Technical alterations / Calibre 2601

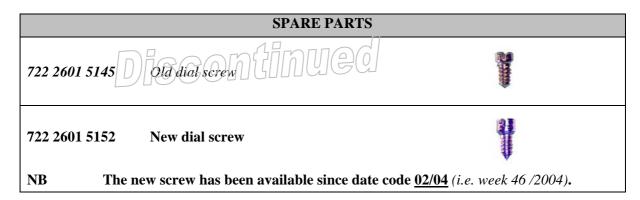
PROBLEM

The dial screw comes loose.

A new stainless steel dial screw with improved thread and a longer head has been produced.

The reference number for the dial screw has been changed. The old version of the screw has been removed from our stock, and we recommend that this old screw should now be replaced by the new version.
